HARLEY DAVIDSON WAREHOUSE PLAT

SUMMARY

| <p>Owner Terry Robinson</p> <p>Applicant Jon Baines</p> <p>Project Planner Michaëlle Petion</p> | <p>Property Location: 3702 37th St. (north and west of I-4, east of Vineland Rd. and south of LB McLeod Rd.) (Parcel ID #09-23-29-0000-00-032 ; ±1.36 acres, District 6)</p> <p>Applicant's Request: The applicant is requesting a Minor Plat to plat previously unplatted lot.</p> | <p>Staff's Recommendation: Approval of the request, subject to the conditions in this report.</p> |

PROPOSED PLAT

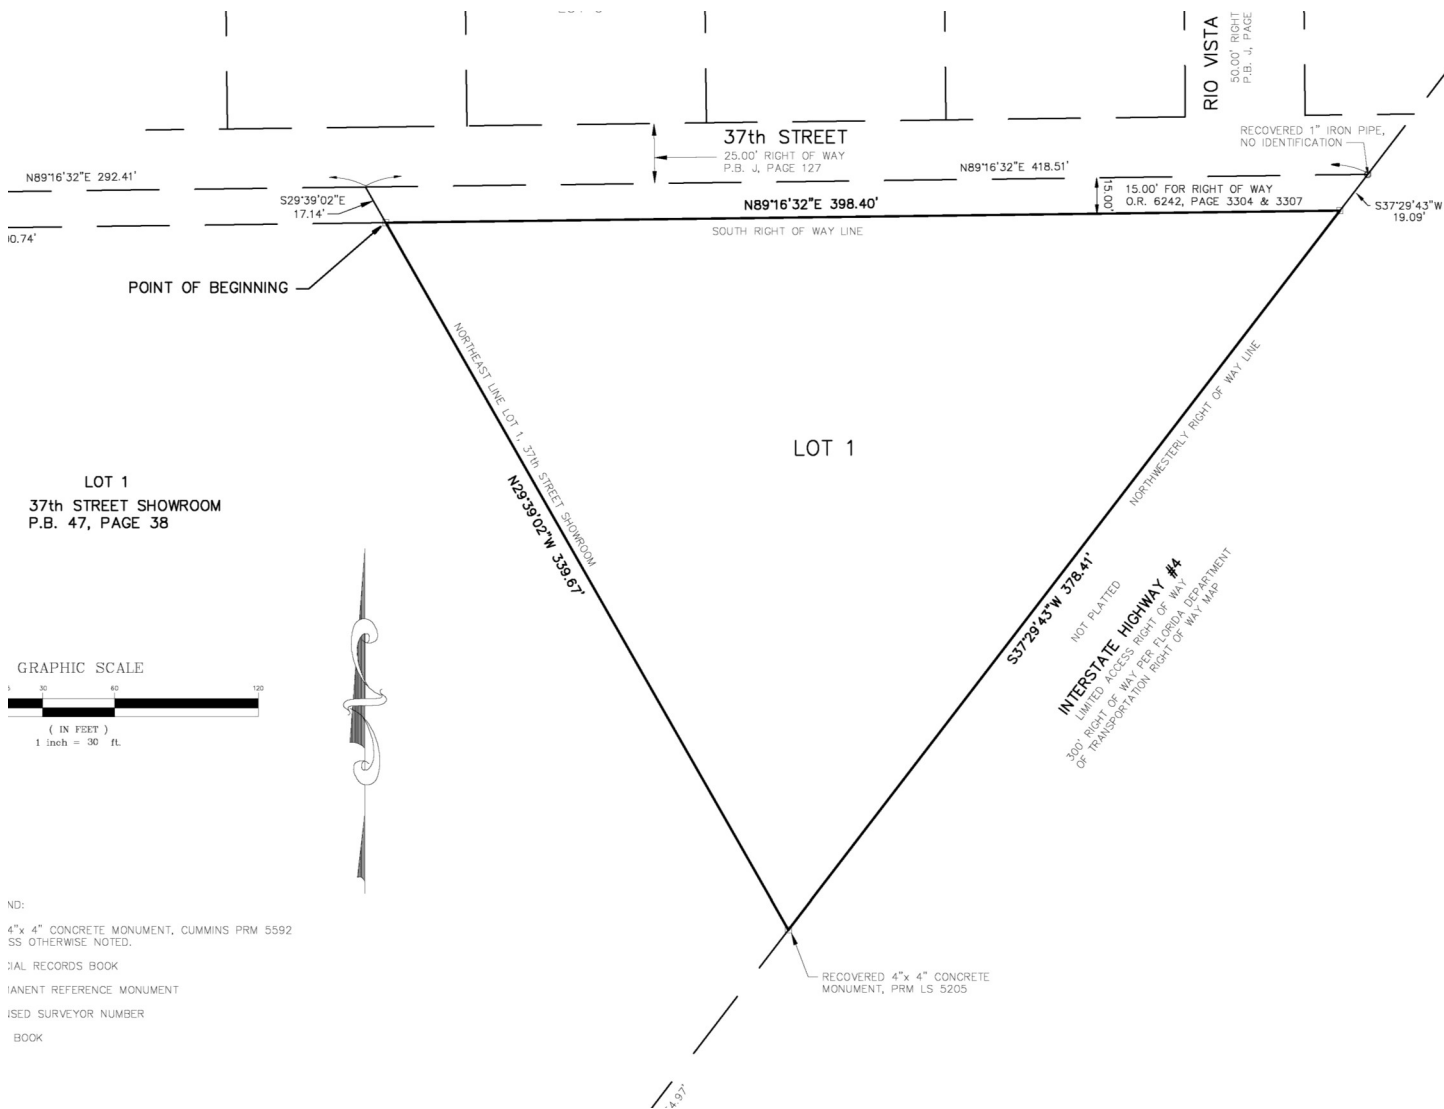
1. Plat— Minor. Plat Face Changes - There are a number of changes required to the face of the plat. In addition to the changes required on the plat, the following is a list of additional requirements.

- 1) Changes to the face of the plat.(A copy has already been returned to the surveyor).
- 2) Recording Fees (Checks should be made payable Orange County Comptroller.)
- 3) The plat must be reviewed by Orange County prior to recording. Begin this process by taking a copy of the executed plat to Room 1700 (Orange County Property Appraiser's Office, Attn. Rocco Campanale), 200 S. Orange Avenue, Sun Trust Bank Center. The original completed Statement of Lien from Orange County is required by this office. The Statement of Lien must be received by this office prior to recording the plat.

2. Sewer. The Plat is unclear if there is a sanitary sewer connection from 3702 37th St to City sewer, and if so, where the connection is made. 3770 has a private lift station with a force main connecting to City sewer. Does 3702 utilize the lift station at 3770? If so, is there an agreement between the 2 parcels?
